Beaver Creek Coal Company  
P.O. Box AU  
Price, Utah 84501  
Telephone 801 637-5050

November 8, 1983

Regarding Beaver Creek Coal Company's Gordon Creek No. 2 Mine Southwest Lease Exploration Project, the company is proposing to substitute a 36" culvert for the chute drop structure that was presented in the exploration plan (p. 3-48). The culvert will require less maintenance and will be easier to install while serving the same purpose as the drop chute.

# HIGHWALL CULVERT

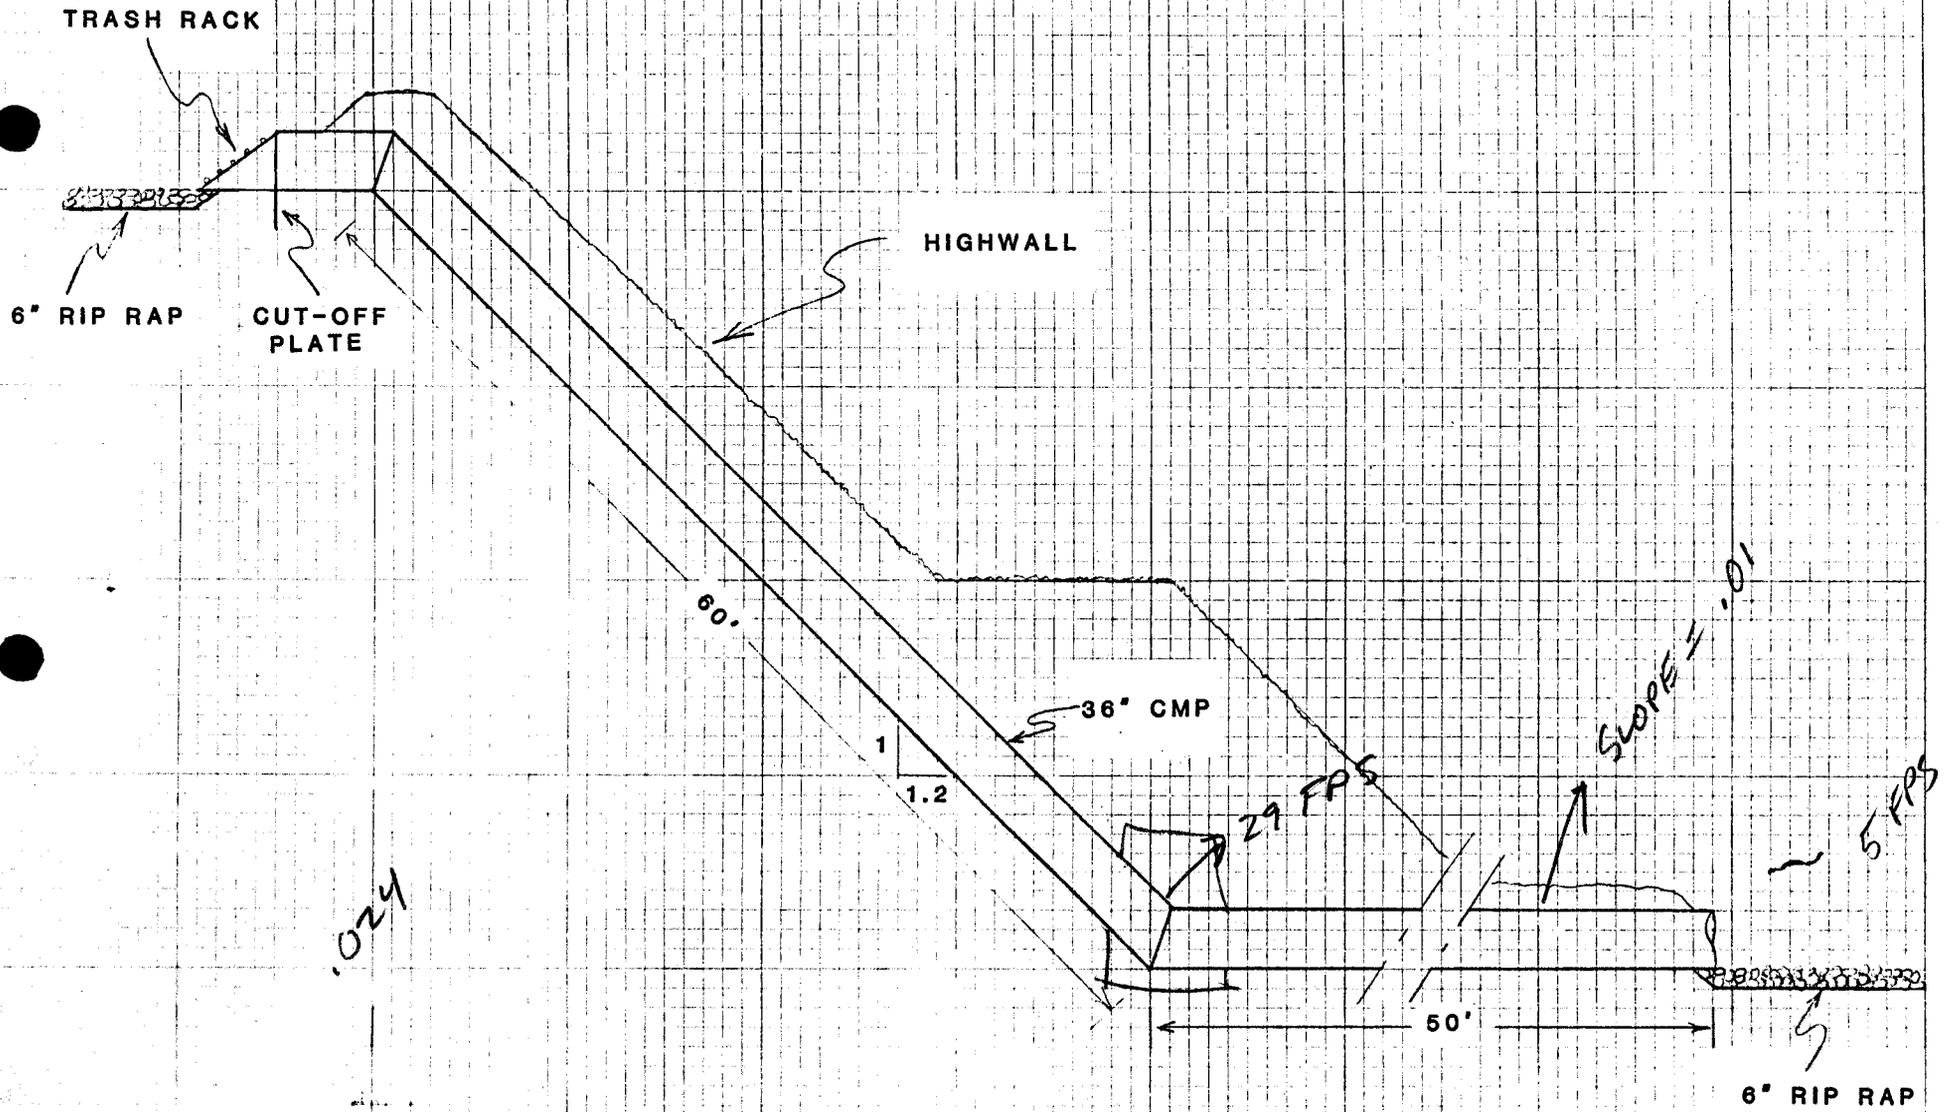
Because the runoff velocity at the base of the slope will be greater with the CMP culvert than with the grouted rip-rap drop chute, Beaver Creek plans to install 50 feet of horizontal culvert prior to discharge into the Bryner Canyon channel. Rip-rap with a median diameter of six (6) inches will be used as final outlet protection. Details of the culvert and it's outlet control are provided in the enclosed drawing.

DESIGN DISCHARGE OF 7.74 CFS REQUIRES 24" CMP  
36" CMP WILL HANDLE 30 CFS

Fig. 4-18. Inlet control nomograph for corrugated steel pipe culverts. The manufacturers recommend keeping  $HW/D$  to a maximum of 1.5 and preferably to no more than 1.0.

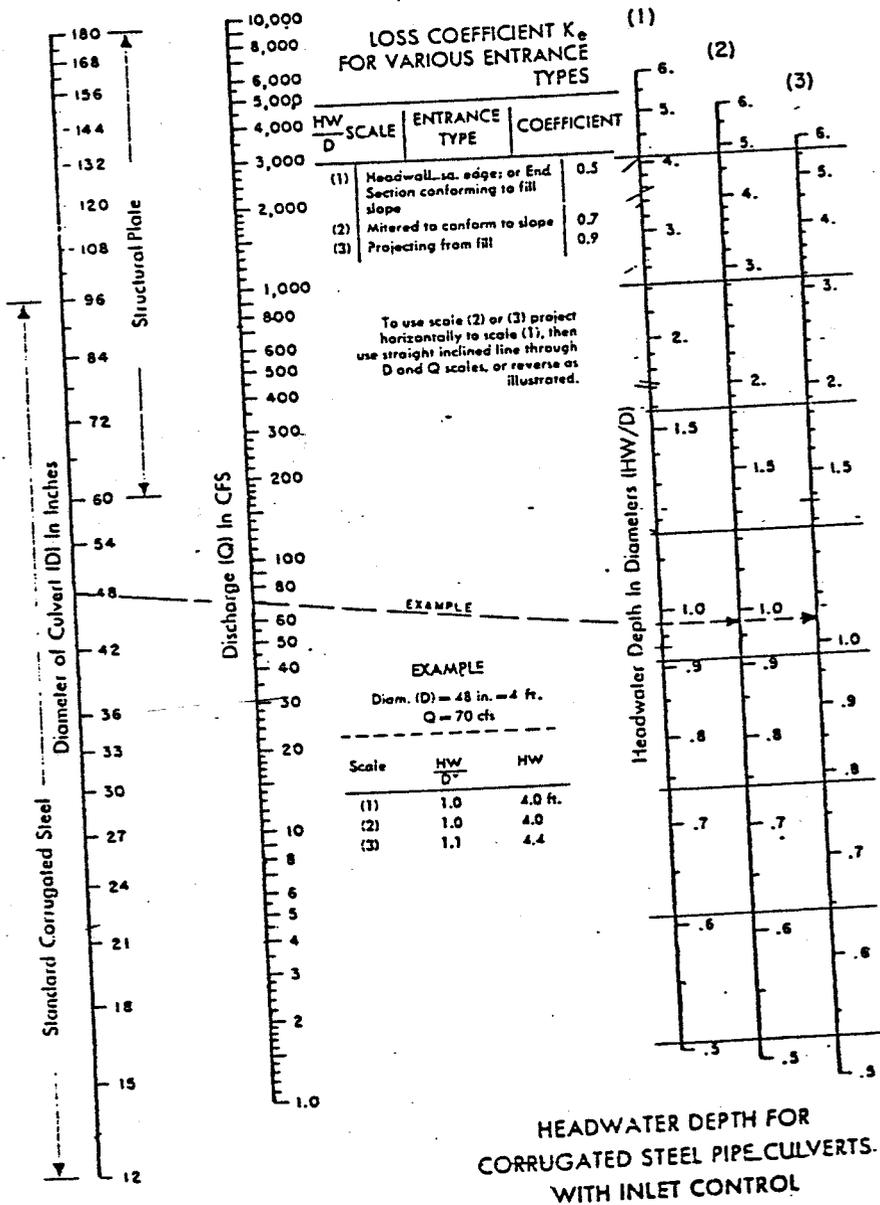
The culvert was sized to accomodate the 25 year, 24 hour peak discharge calculated for the Left Fork of Bryner Canyon (p. 3-47). The enclosed nomograph was used in the sizing procedure.
